INFORMATION BULLETIN

Bulletin No: JC-007-08

430 Steering Valve (23-054) Change

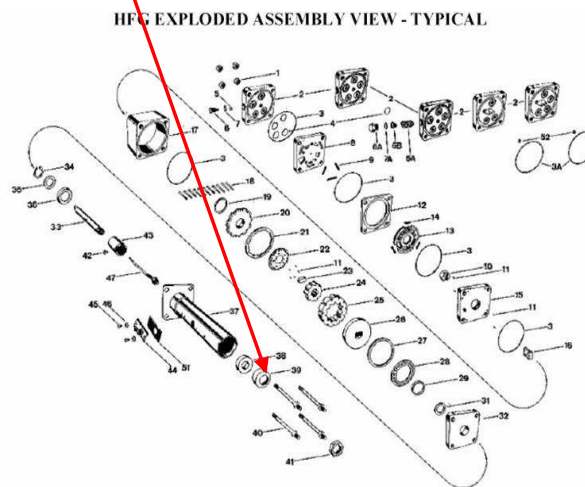
ISSUE: The Parker Steering valve has changed the steering Shaft from $\frac{3}{4}$ " to $\frac{7}{8}$ " which means the original dust seal listed in the parts list (21-402405) will NOT fit the newer steering valves.

CORRECTION: We will update the part breakdown in the near future but in the meantime you will need to make note of the $\frac{7}{8}$ " seal. **The new $\frac{7}{8}$ " seal is part number 21-402407.**

ACTION REQUIRED: Do **NOT** supersede part 21-402405 to 21-402407. They are both good numbers and have separate applications.

OLD STYLE $\frac{3}{4}$ " Seal = 21-402405

NEW STYLE $\frac{7}{8}$ " Seal = 21-402407
